valken®

GOTCHA™

UPGRADE AND COMPATIBILITY GUIDE

GOTCHA REVISION PRODUCTION TIMELINE AND HISTORY

PUMP SHELLS

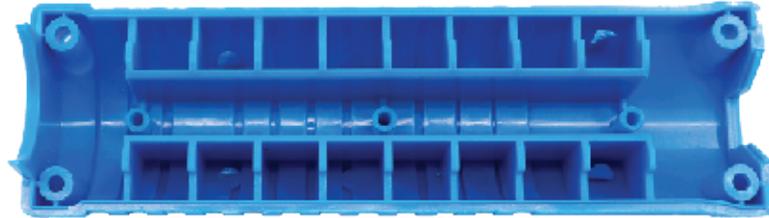
Revision 2 has a thicker base to the pump arm screw studs and two joiners that match the pump arm. Revision 2 pump shells require revision 2 pump arm(88111).

Revision 3 thickened the studs and added an additional crosspost. Revision 3 pump shells require revision 3 pump arm(102114)..

Revision 1 - 2**Revision 3****INNER BARREL**

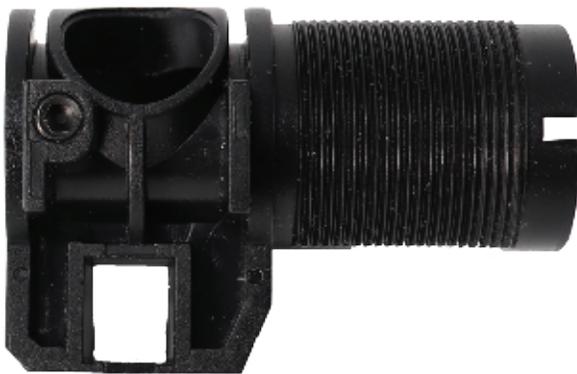
Revision 3 is much longer with the bucking cut out moved forward. Revision 3 requires revision 3 bolt (102015) and bucking (102046-Black, 102022-Blue, 102039-Red).
